Re: Seacoast Reliability Project - SEC Docket 2015-04 Notification of Minor Construction-Related Changes

The following changes—which do not meet the definition of a significant amendment—are briefly discussed below, tabulated in Table 1, and depicted in the attached drawings.

Table 1. Seacoast Reliability Project wetland impact changes due to construction modifications.

Map 8 of 31

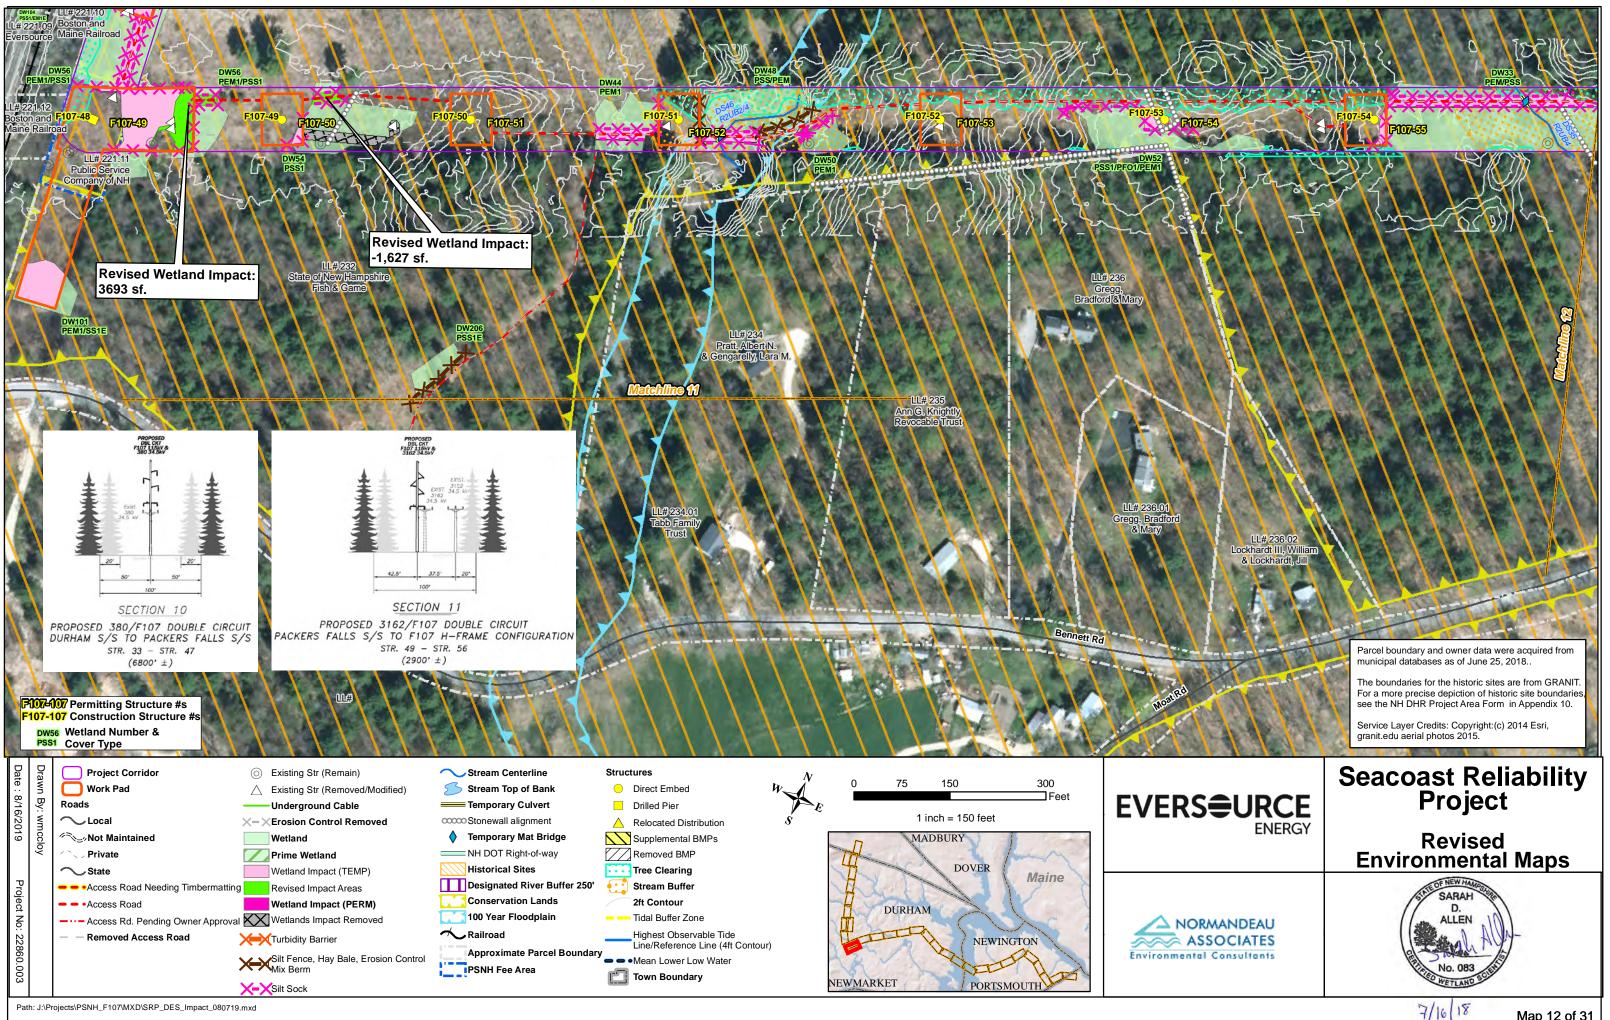
- Structure 39, Map 8. The access road was shifted to the west to use a more complete breach in the stone wall, and further reduce wetland impacts. This change results in a decrease of 648 sf of temporary wetland impact to DW 46.
